Salado Pressure Zone 1295 Booster Pump Station Project
SAWS Job No. 14-6102
Solicitation No. CO-00120

ADDENDUM No. 2

April 13, 2017

JOB NO. 14-6102
SALADO PUMP STATION
TO STONE OAK WATER MAIN
CRADLE BLOCK & STRAP

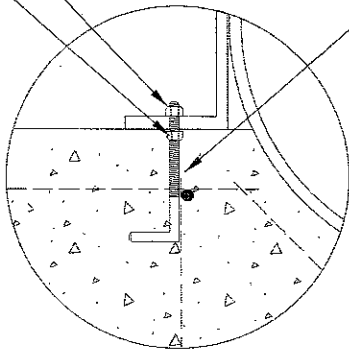
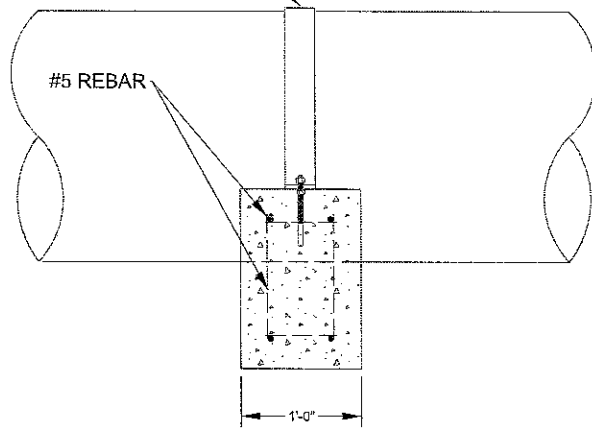
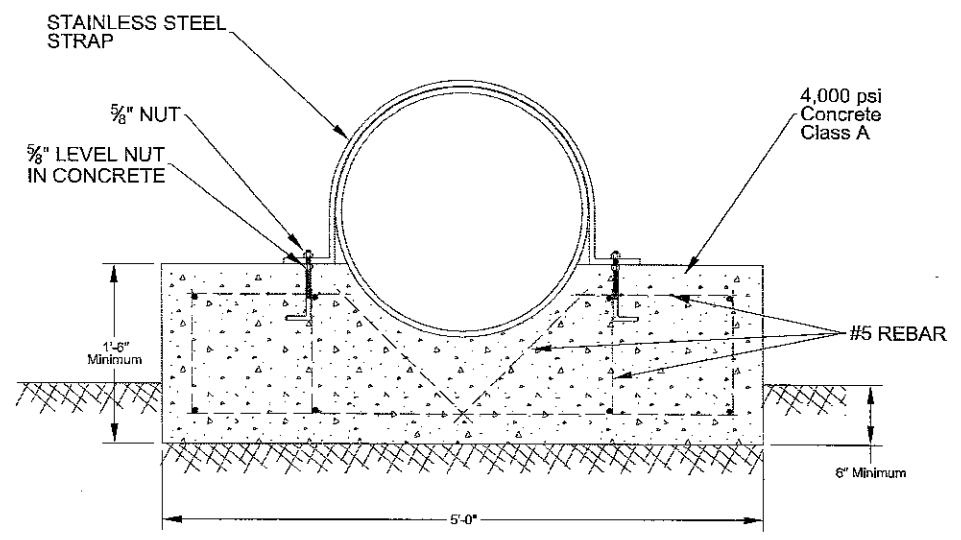
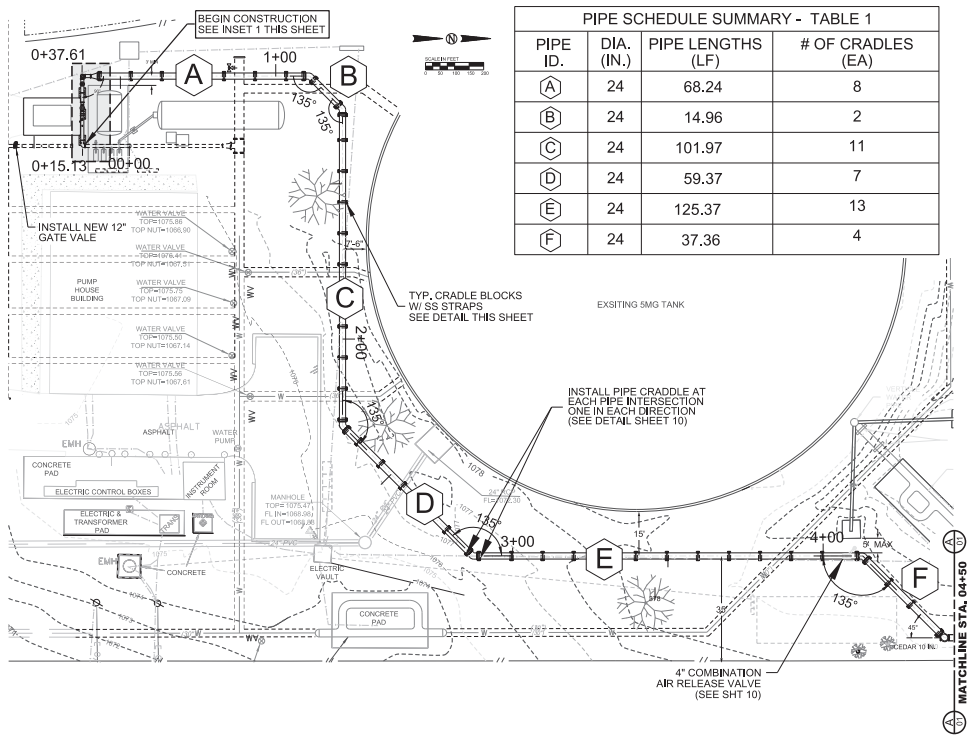
- 1.8.** There are numerous concrete pipe support blocks(50+) for the above ground 24” pipe currently on site. Is there a detail for the supports? If so please provide for review.

- 1.9.** On the supports mentioned above..., is there a respective ‘footing’ below ground?...i.e. a small ‘pier’ or a larger concrete footprint below the surface of the ground?

Response: Yes. Please find details attached of the concrete pipe support blocks at the end of the document.

Response: There are no piers below the concrete pipe support blocks. See attached detail sheets for the installed concrete pipe support blocks.

DRAWING NO.
PL1
7 of 11

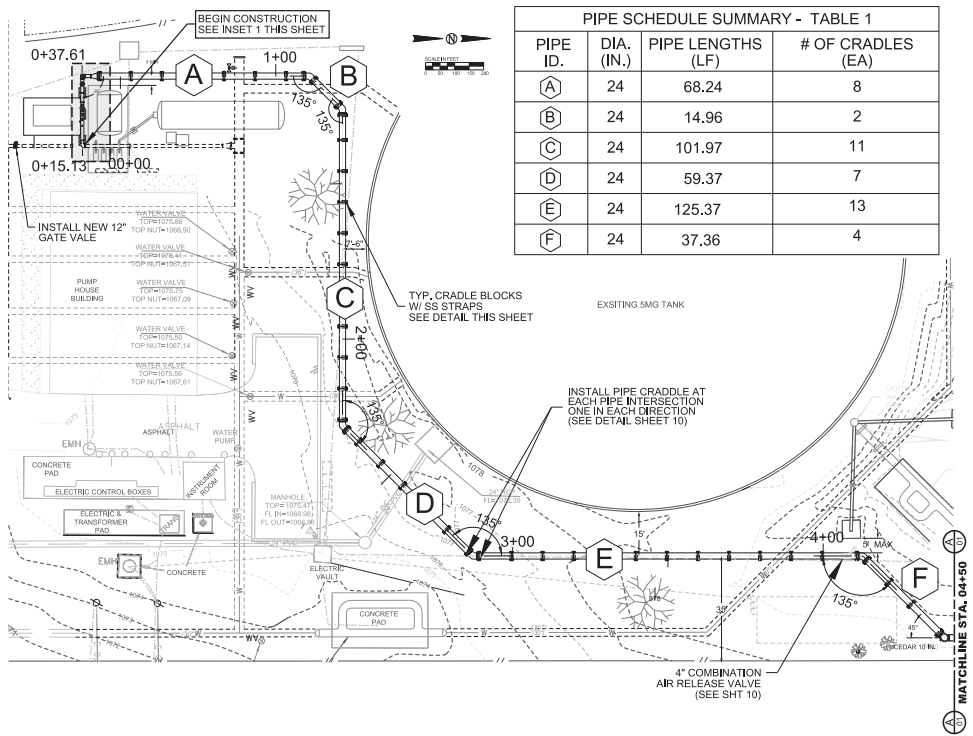
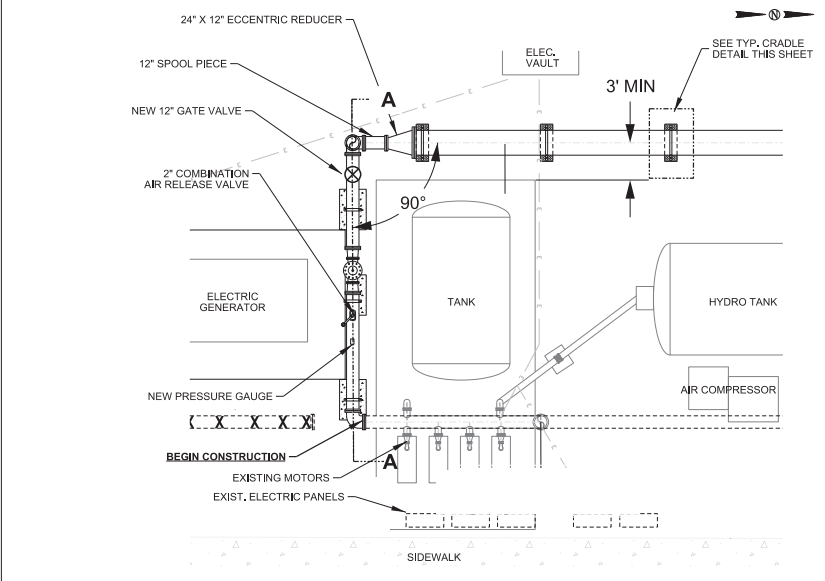
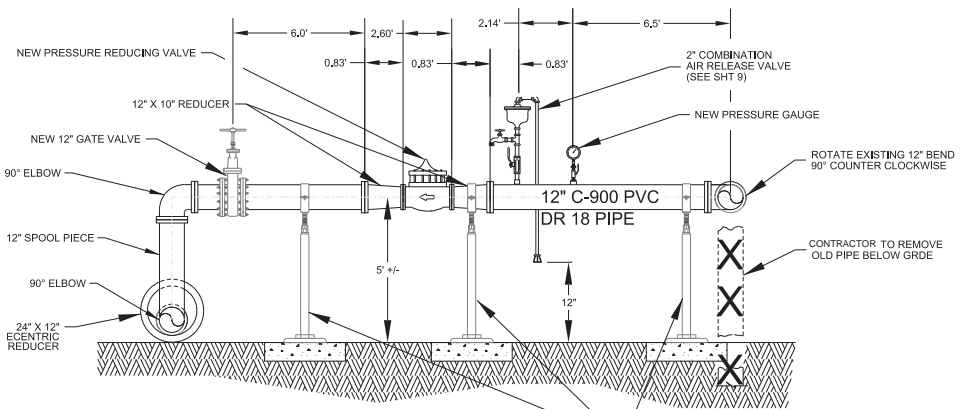
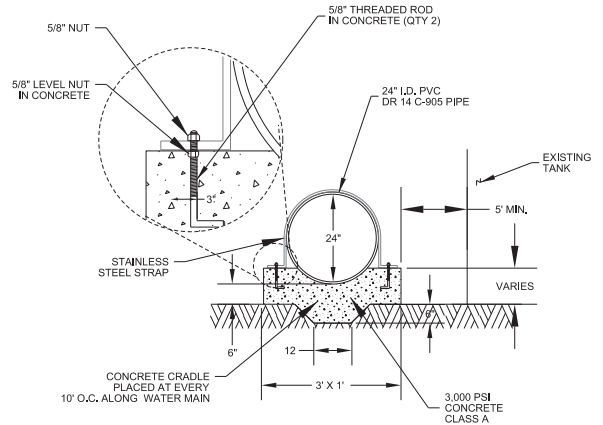
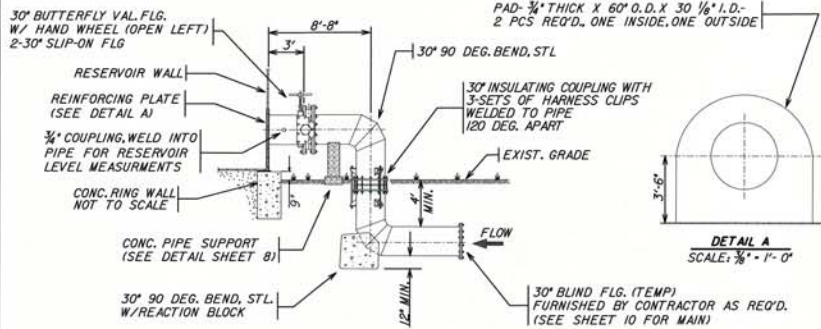
After the pump station is operational and the piping removed, how does the 12" Piping connect to PZ 1400? There is no detail 1.

Response: See attached drawing PL1, 7 of 11 from the plans for the construction of the temporary piping system. Connect 12-inch ductile iron pipe from the buried gate valve shown on the south side of the skid mounted pump station. Extend 12-inch ductile iron pipe north to a 90-degree bend to vertical in line with the 90 degree bend on the end of the discharge header of the pump station. Turn the top 90-degree bend to face down and connect the required length of 12-inch ductile iron pipe vertically between the two bends. Provide a restrained coupling immediately above ground level to facilitate installation and dismantling.

F TYPICAL 36° OUTLET PIPE DETAIL
SCALE: 1" = 5'

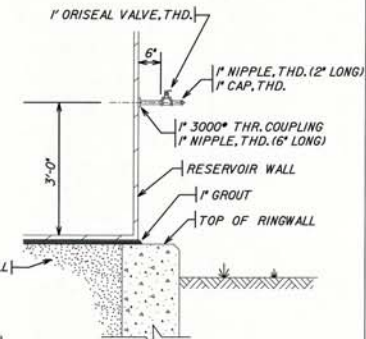
Is there a sketch or drawing of the area inside the tank where the 36" plug is to be installed?

Response: Attached to this addendum is Sheet 5 of the plans for the Salado Tank with a typical tank outlet detail to be used for general reference.
